18 June 2025

Our Ref: 695-22

RE: Draft Report – Assessment of The Hills Shire Council Contributions Plan No 15 - Box Hill Precinct – April 2025

Figure 3: Signalised intersections in the proposed Box Hill Business Park
(Source: Traffic and Warrant Study prepared by The Hills Shire Council)

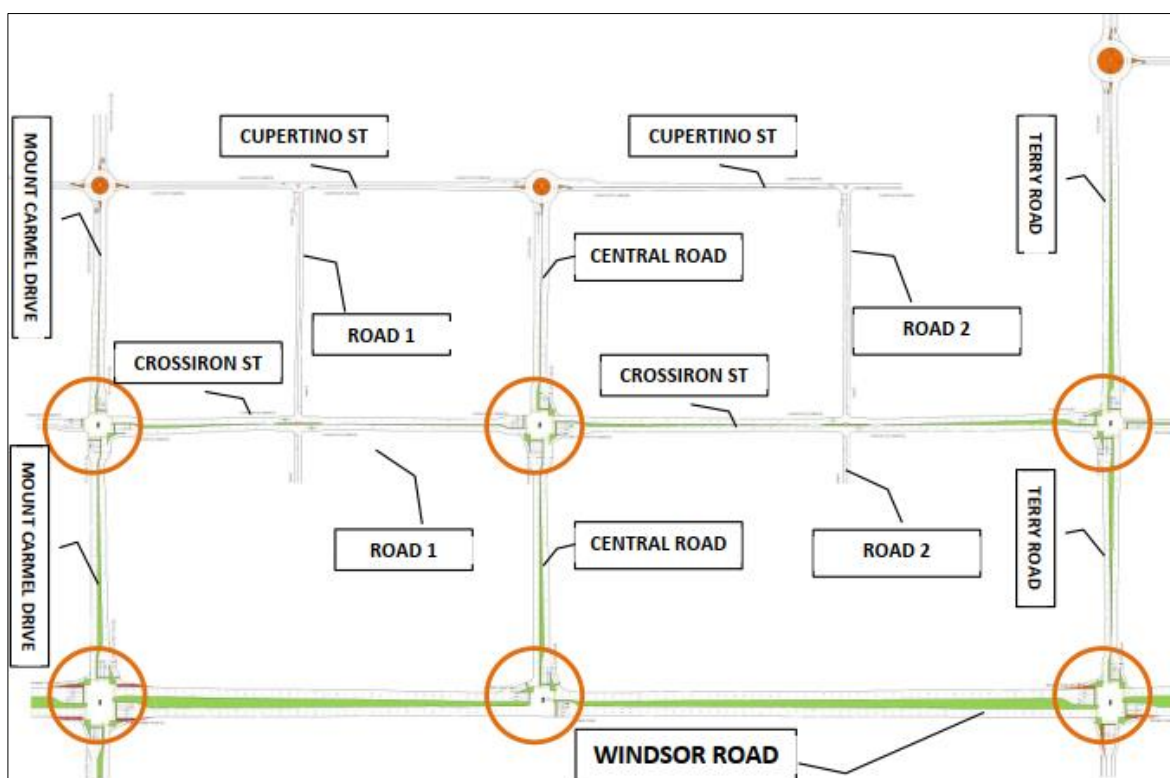
The locations of these intersections are shown in **Figure 3**. It is also noted that the traffic and warrant study recommend that Windsor Road be widened to three lanes in each direction (six lane divided carriageway).

The proposed intersection and road network upgrades have been reviewed and based on the details of this assessment, could be considered oversized in terms of appropriately facilitating business park access. The extent of the upgrades is largely dictated by the tidal flow of vehicles due to the assumptions adopted in the traffic study on account of the assumed single office land use assessed. This is evident with the planned introduction of dual right turns at several intersections, including the northern and eastern approaches to the Windsor Road intersections at both Terry Road and Mount Carmel Drive. The Council endorsed layouts of these intersections are shown in **Figure 4**.

Figure 4: Windsor Road/ Terry Road Intersection (left) & Windsor Road/ Mount Carmel Drive Intersection (right)

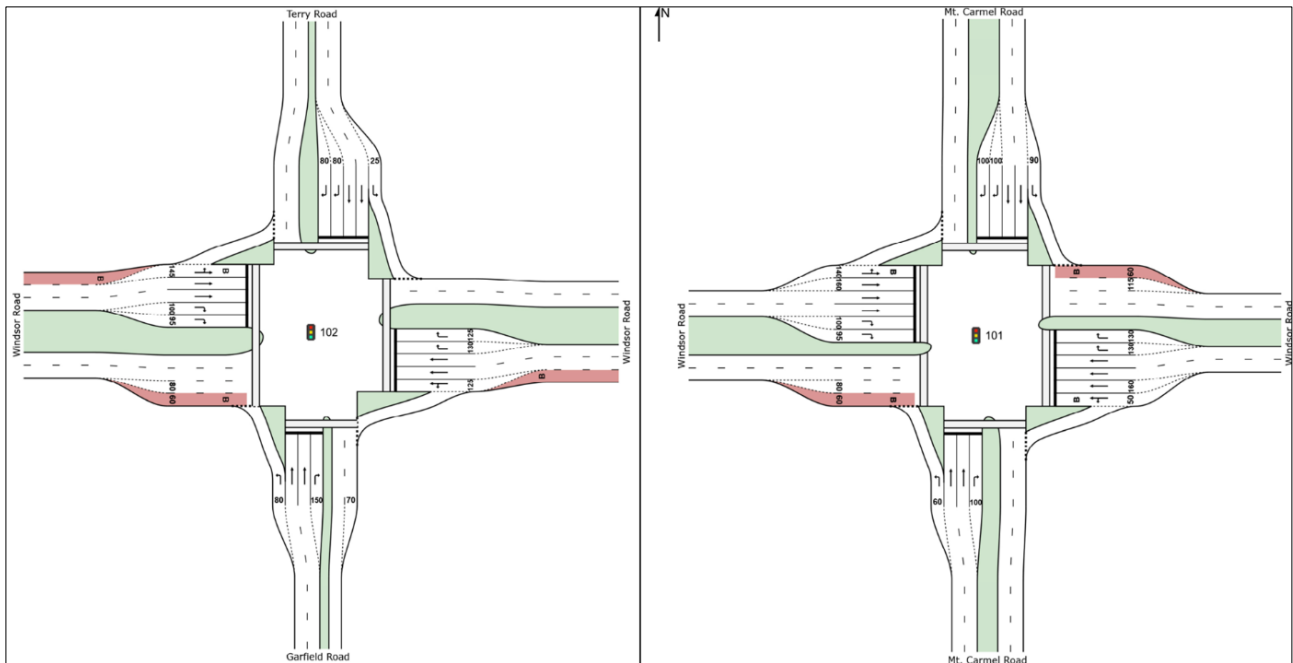
As discussed, and with consideration to the various land uses possible in the business park, the inbound and outbound traffic distribution during the network peak periods will likely vary on account of many developments generating different site peak periods. This would typically result in less 'peak' traffic conditions and more even distribution of two-way traffic flows. This means less tidal traffic conditions and hence, potentially less onerous intersection upgrades. SIDRA Intersection modelling would be necessary to confirm any such amended outcomes.
